Access Compliance Report

Public Rights-of-Way

(Curb Ramps)

Intersection ID: 51054	Main Street: MULBERRY_CHURCH_RD	Cross Street: N/A	Location: SW
ADA ID: 90FC51242E87	Ramp Type: BlendTrans1	Initial Pass/Fail: Fail	Overall Compliance: No
Codes/Mitigation Info/Possible Solution		Field Measurements/Component Compliance	
		Severity Score: 10

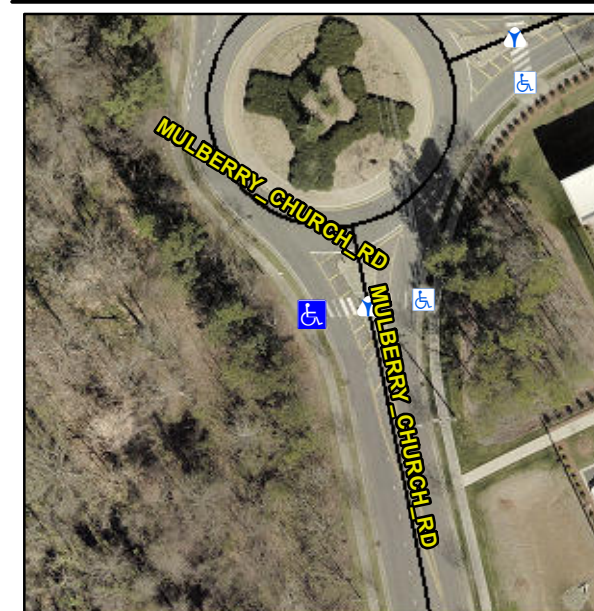
Not Found, R304.5.1, R304.5.3

Compliance	Description	Data	Compliance	Description	Data
N/A	Ramp Length (in)	48.0	Yes	BlendTrans Slope (%)	3.2
No	Ramp Width (in)	47.0	No	BlendTrans XSlope (%)	2.6
N/A	Flare Type LT	N/A	N/A	Flare Type RT	N/A
N/A	Flare Slope LT (%)	N/A	N/A	Flare Slope RT (%)	N/A
N/A	Flare Traversable LT?	N/A	N/A	Flare Traversable RT?	N/A
N/A	Landing Length (in)	N/A	N/A	DWS Provided?	N/A
N/A	Landing Width (in)	N/A	N/A	DWS Contrast?	N/A
N/A	Landing Slope (%)	N/A	N/A	DWS Length (in)	N/A
N/A	Landing X Slope (%)	N/A	N/A	DWS Full Width?	N/A
N/A	Landing Curb? (Y/N)	N/A	N/A	DWS Offset (in)	N/A
N/A	Shared Landing?	N/A			
N/A	Gutter Ponding?	N/A	N/A	Gutter Slope (%)	N/A
N/A	Gutter Lip Ht (in)	N/A	N/A	Gutter X Slope (%)	N/A
N/A	Painted X Walk1?	Yes	N/A	Painted X Walk2?	N/A
	X Walk 1 Direction	To E		X Walk 2 Direction	N/A
	X Walk 1 Width (in)	116.0		X Walk 2 Width (in)	N/A
	X Walk 1 Slope (%)	1.9		X Walk 2 Slope (%)	N/A
	X Walk 1 X Slope (%)	1.3		X Walk 2 X Slope (%)	N/A

N/A	Ramp inside XWalk1?	Yes	N/A	Ramp inside XWalk2?	N/A
	Road Slope (%)	1.3		Clear Space?	N/A
	Road X Slope (%)	1.9	N/A	Clear Space to XWalk (in)	N/A
N/A	Any Obstructions?	N/A	N/A	Storm Grate/Utility Hazard?	N/A
	Obstruction Type			Storm Grate/Utility Type	
		N/A			N/A
			Yes	Surface Condition? (G/P)	Good
			No	Curb Slope (%)	17.0

Remove & Replace Curb Ramp With Two New Directional Ramps or Equivalent.
